HISTORIC RESOURCES PRESERVATION BOARD REPORT

HRPB Project Number 26-00100048: Consideration of a Certificate of Appropriateness (COA) for new construction of a single-family structure of approximately $\pm 7,828$ square feet at 1130 S Lakeside Drive. The subject property is located in the SFR—Single Family Residential Zoning District and has a future land use designation of Single Family Residential (SFR). The property is non-contributing to the South Palm Park Historic District.

Meeting Date: April 8, 2026

Address: 1130 South Lakeside Drive

SHEET NAME:
STREET SCAPE

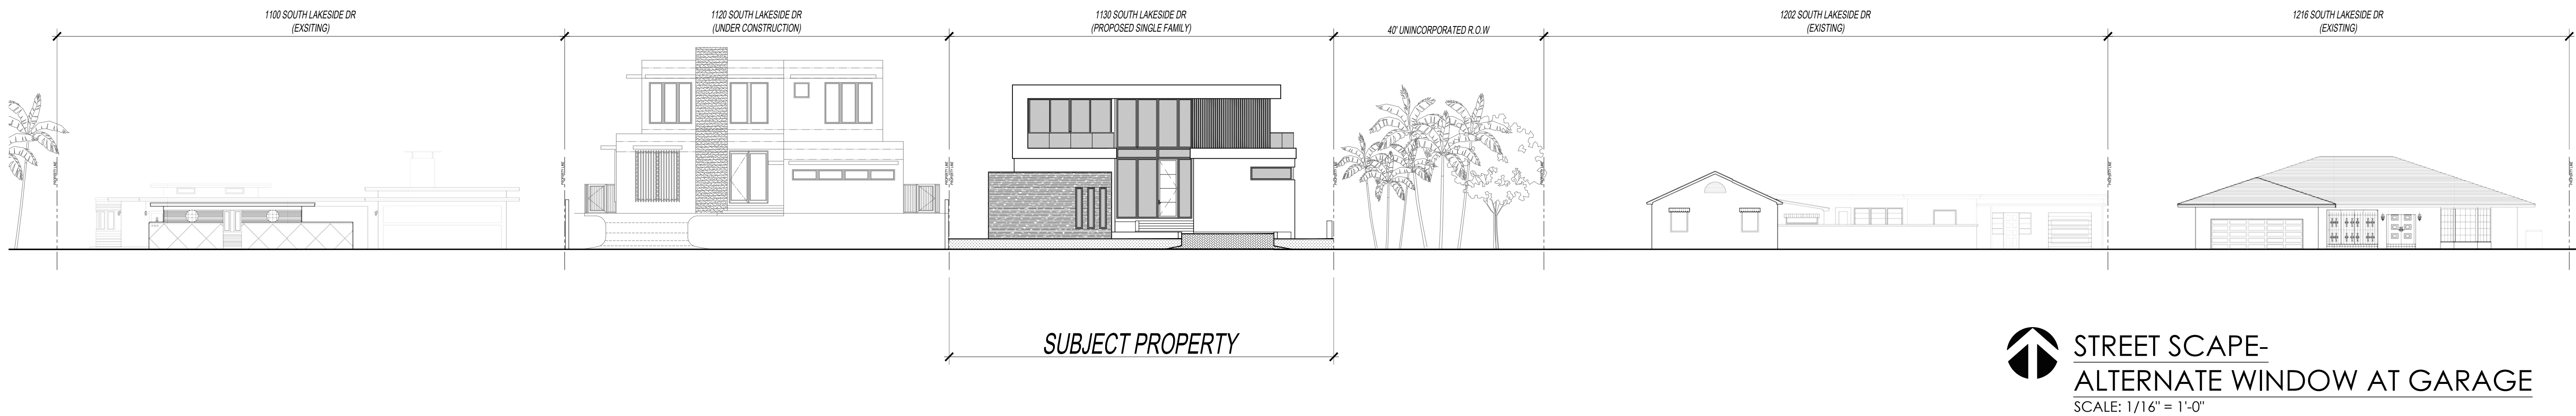
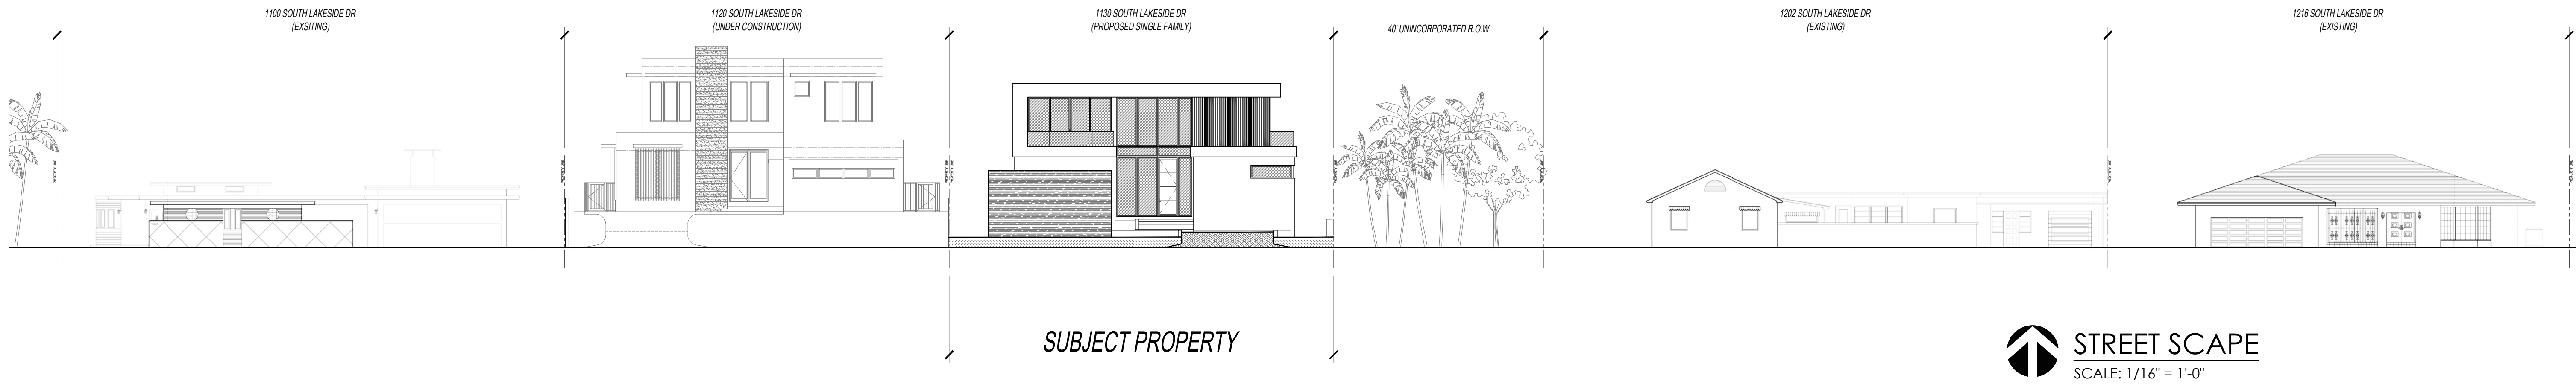
Analysis: The applicant has provided a streetscape showing the building in relation to those properties on either side. The proposed structure is slightly smaller in scale and massing than the related new construction at 1120 S Lakeside Drive, and incorporates an appropriate “stepped down” massing in context with the adjacent unimproved right-of-way and horizontal one-story massing of the structure at 1202 S Lakeside Drive.

**FIRST
 FLOOR PLAN**

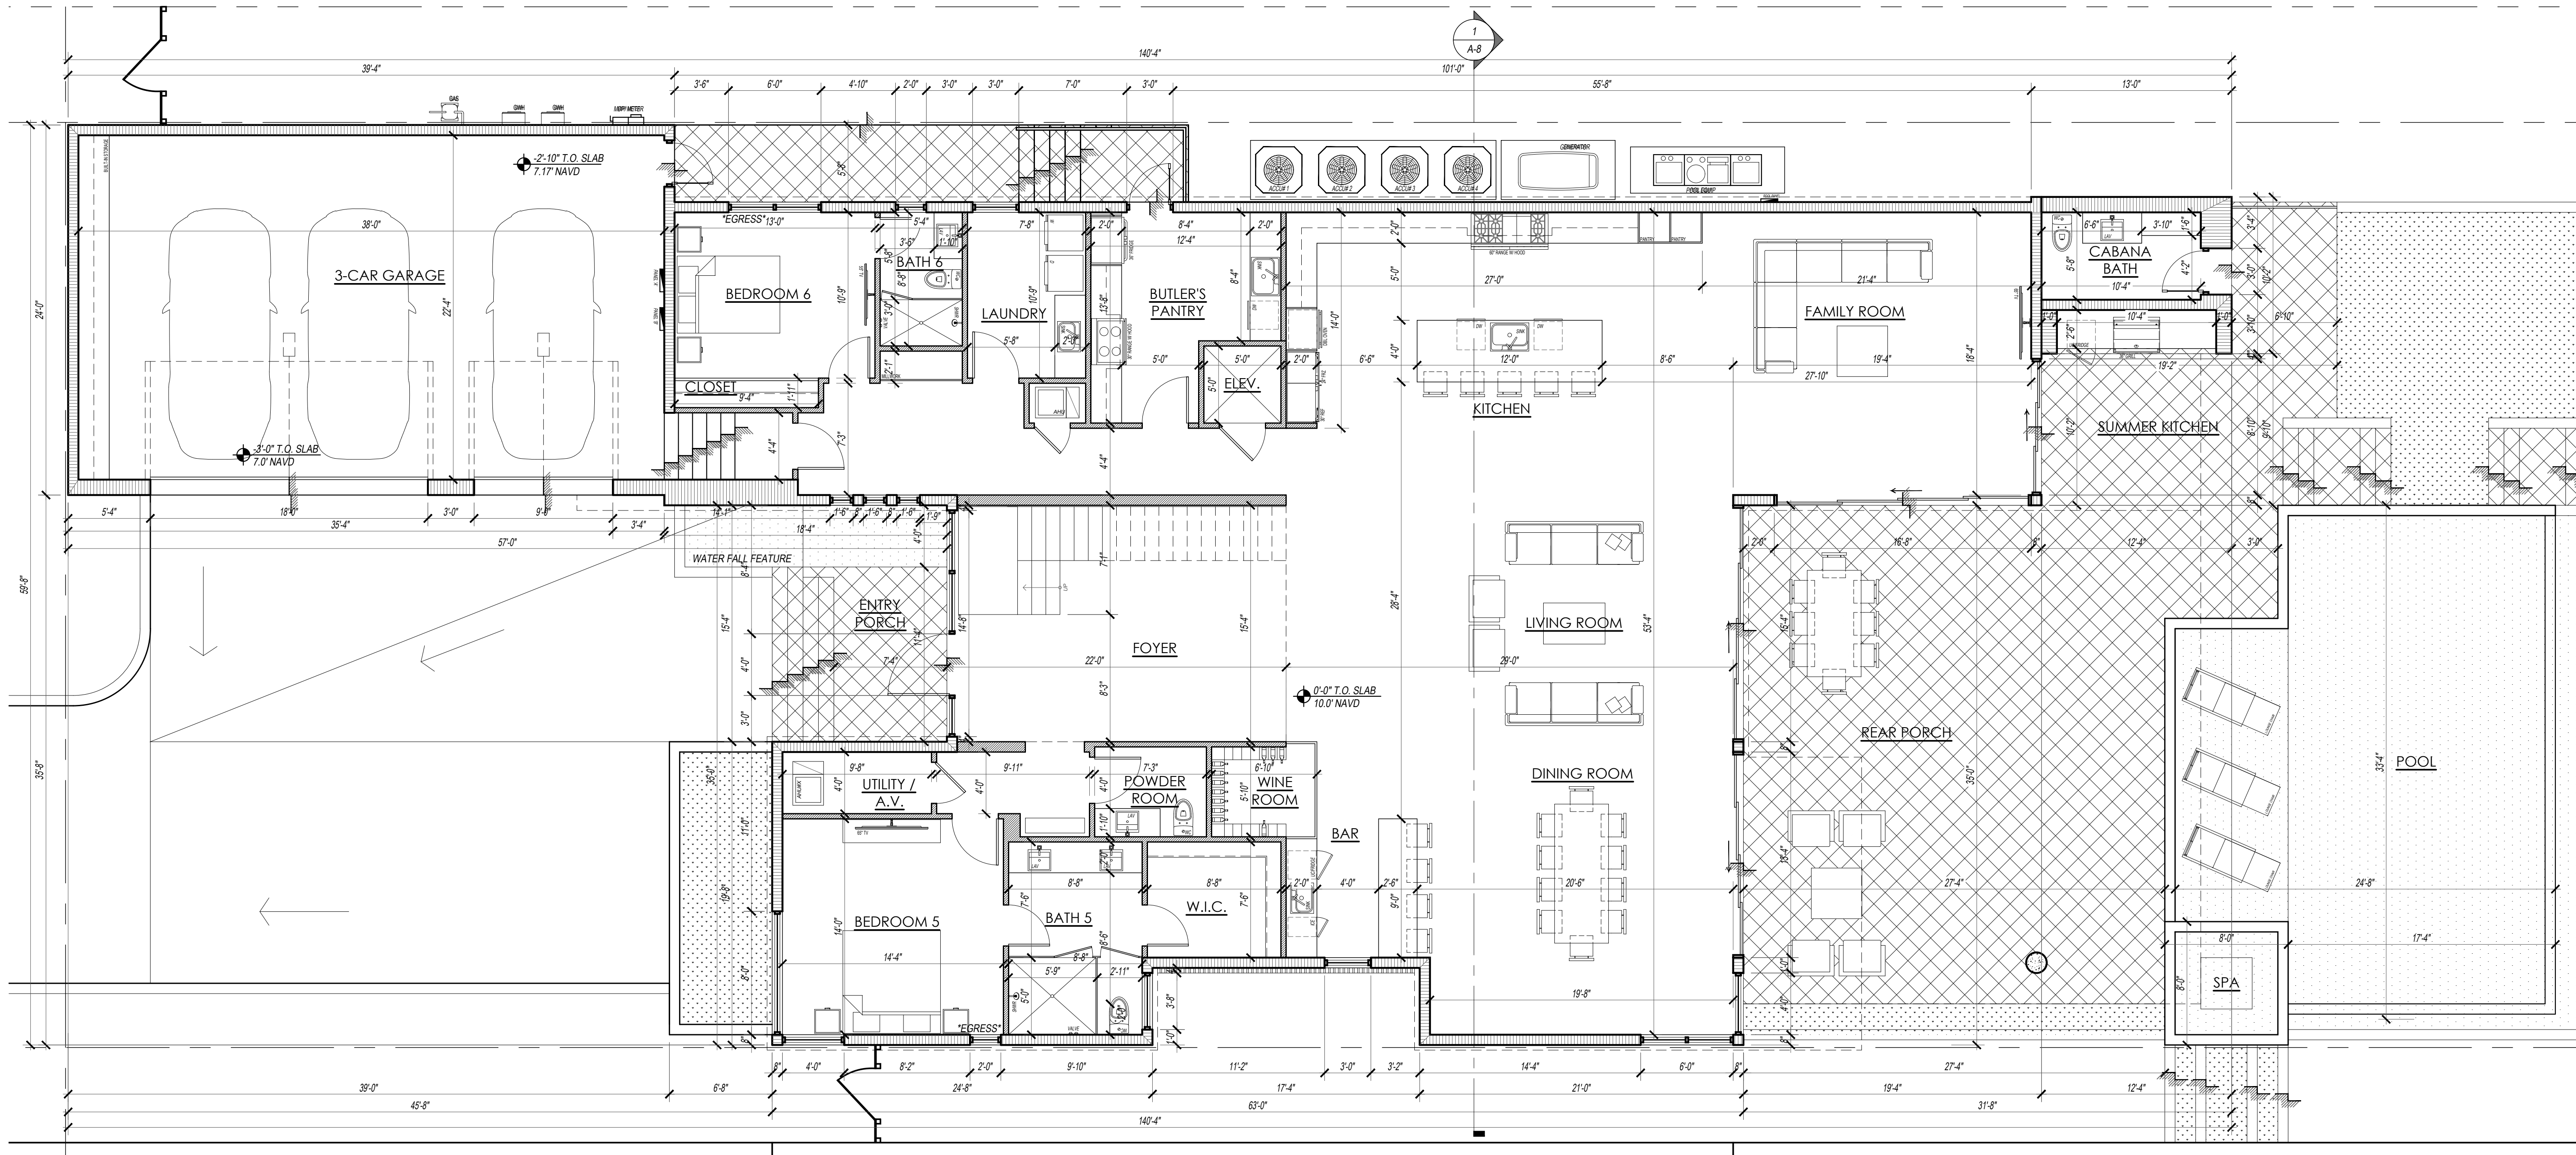
Analysis: The proposed structure is a single-family residence and is consistent with the intent of the Single-Family Residential designation. The proposed floorplan does indicate two oven or range units being installed under the current proposal. The LDRs only permit one kitchen per dwelling unit. As such, staff has added a condition of approval in order to address this.

- 1) The provided "Option 2" with vertical windows on the garage structure shall be approved rather than "Option 1".
- 2) The second range in the "Butler's pantry" shall be eliminated as only one range is permitted per single family property.

1.1
 A-6
**FRONT ELEVATION- WEST-
 ALTERNATE WINDOW AT GARAGE**
 SCALE: 3/16" = 1'-0"

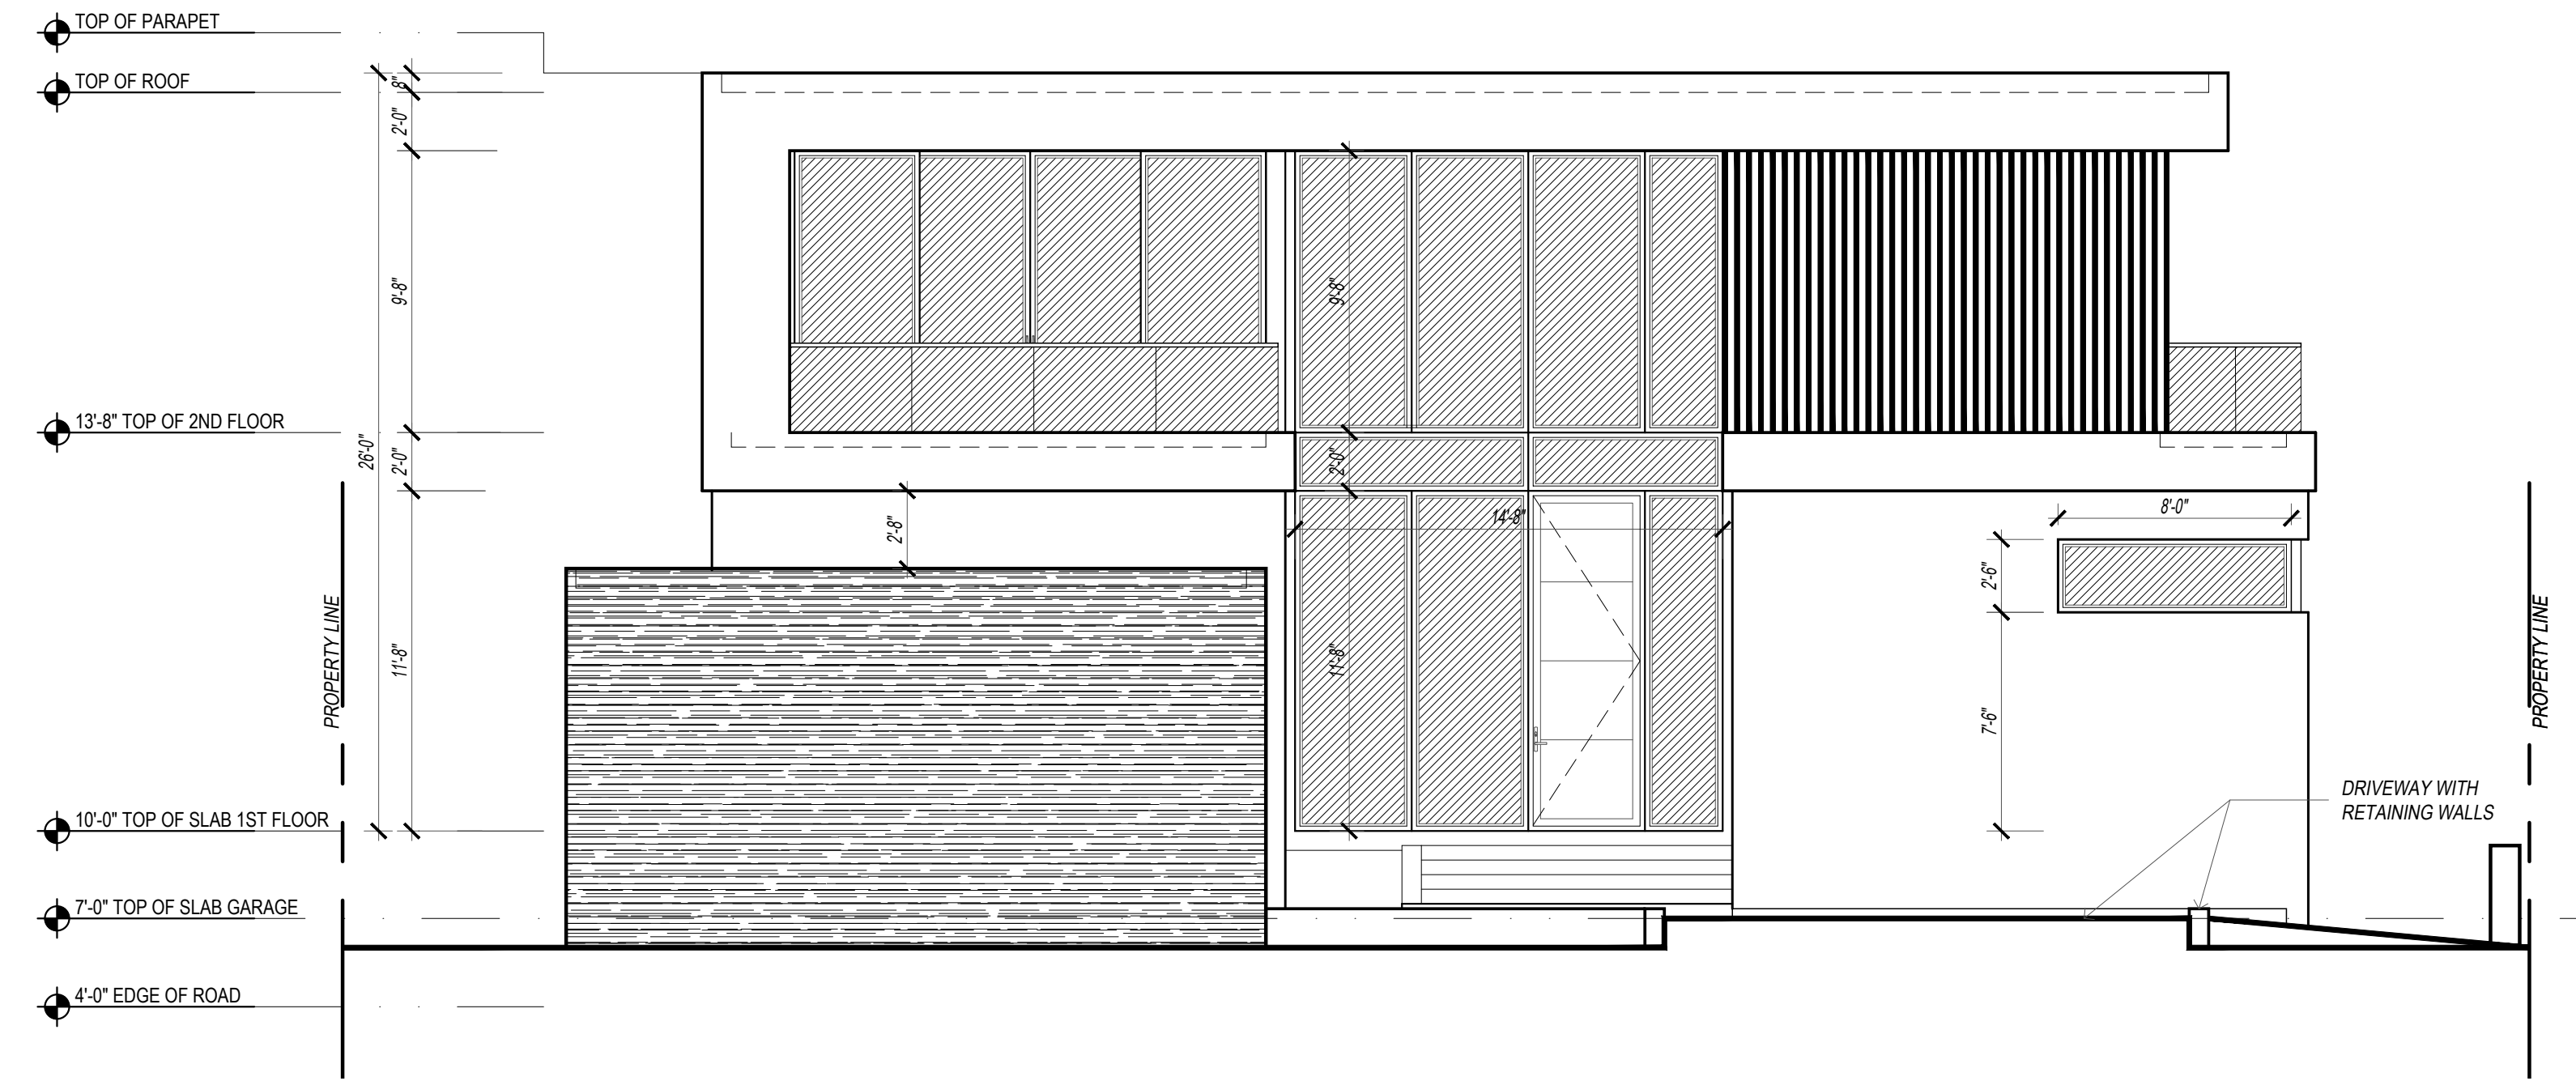
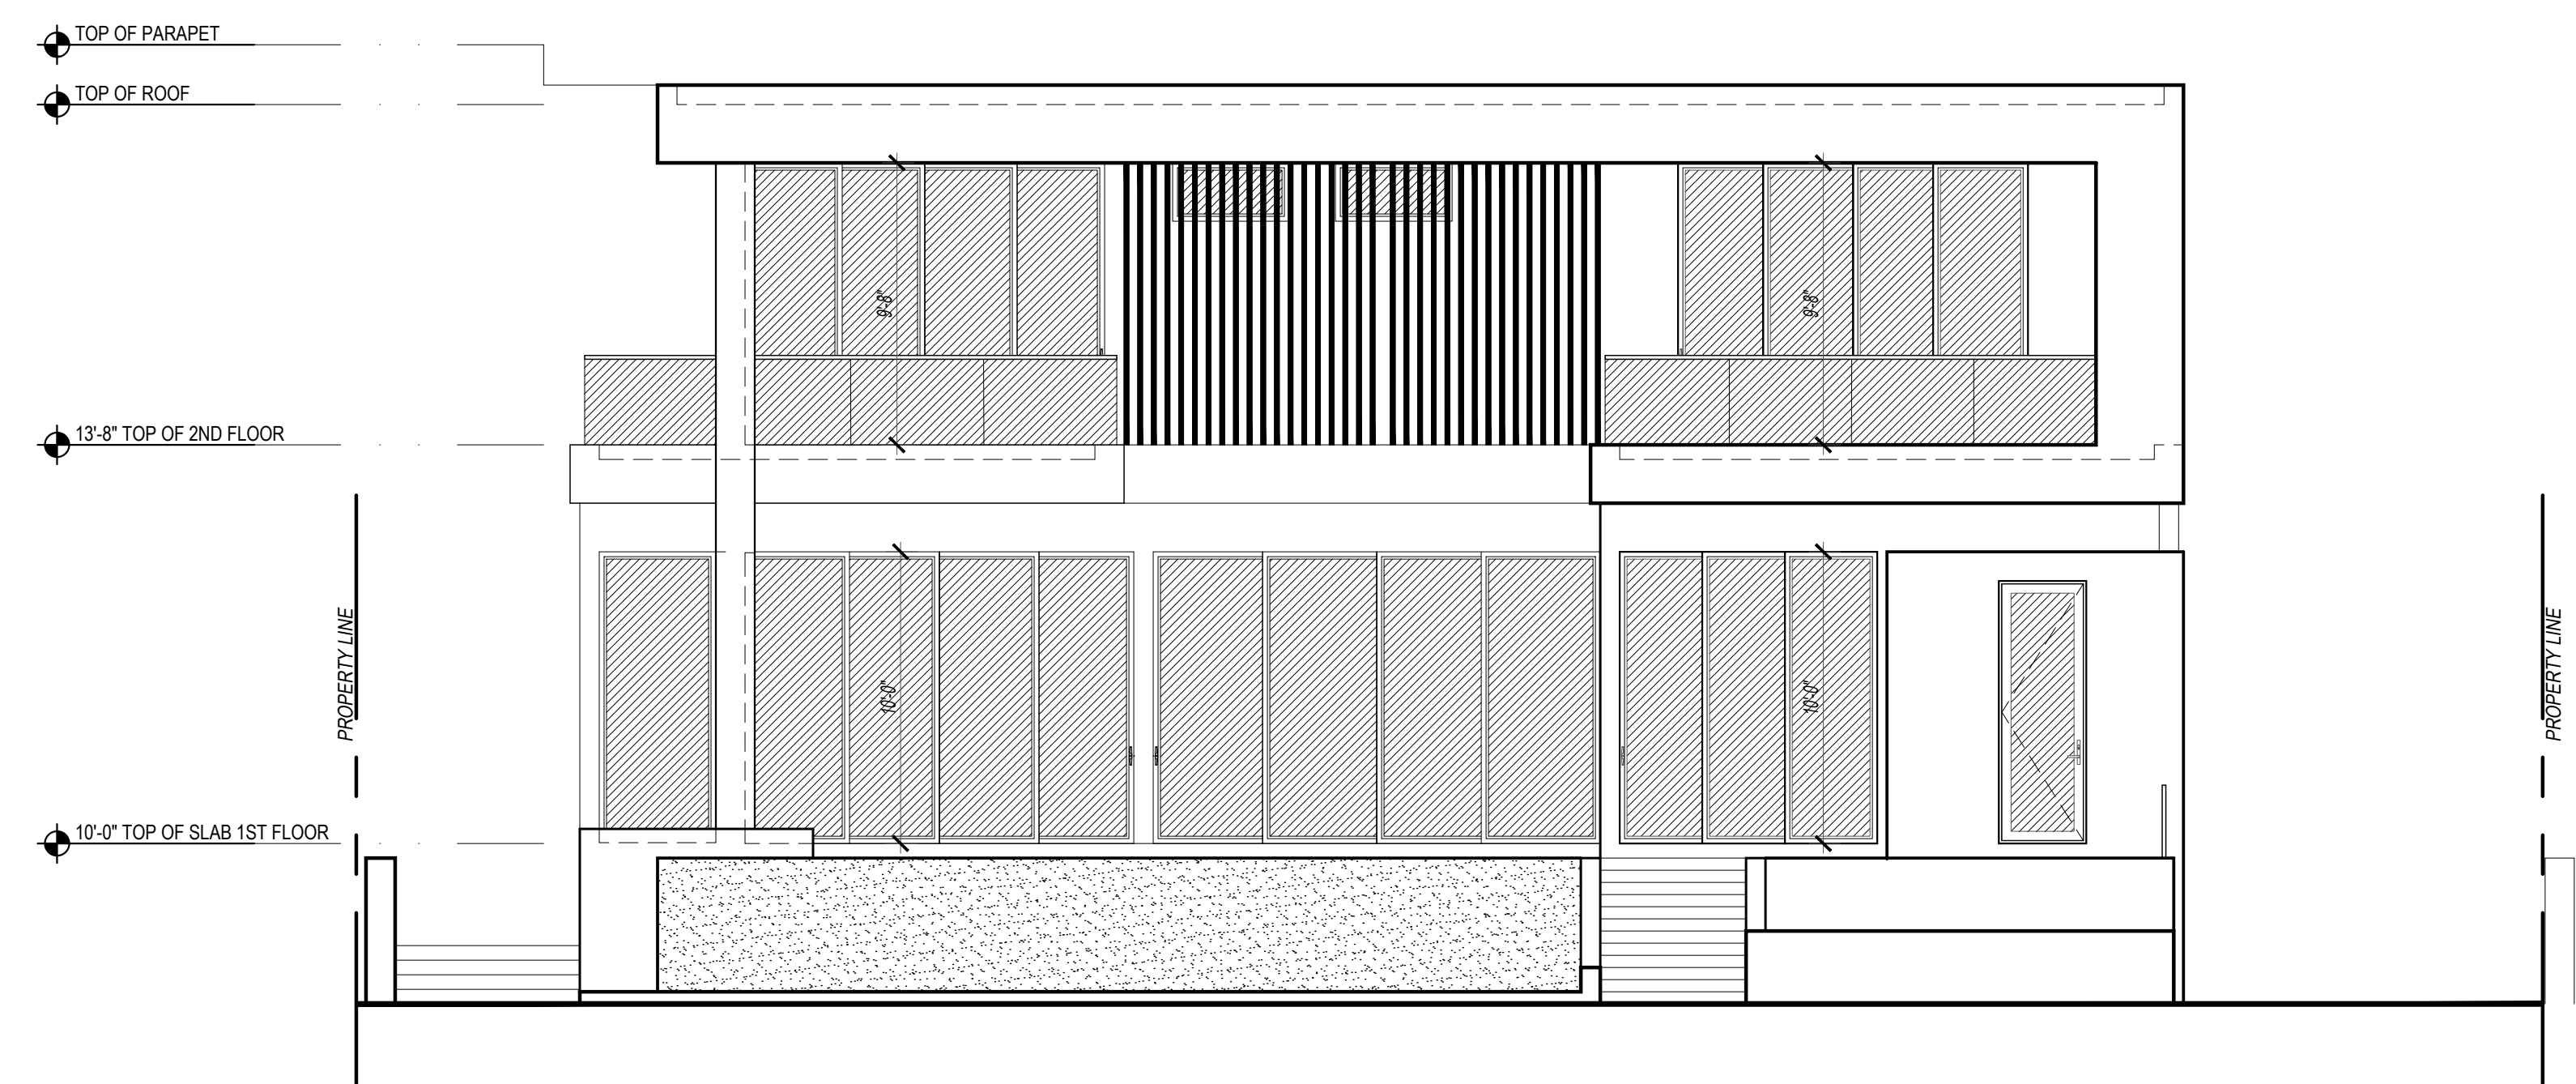
Analysis: The front elevation of the structure successfully avoids expanses of blank façade by staggering the planes of the façade, providing a deep overhang of the second story roofed balcony and providing a pleasing arrangement of windows along the façade. While “Option 1” features a blank façade along the garage facing South Lakeside Drive, “Option 2” provides a break by incorporating 3 small vertical windows.
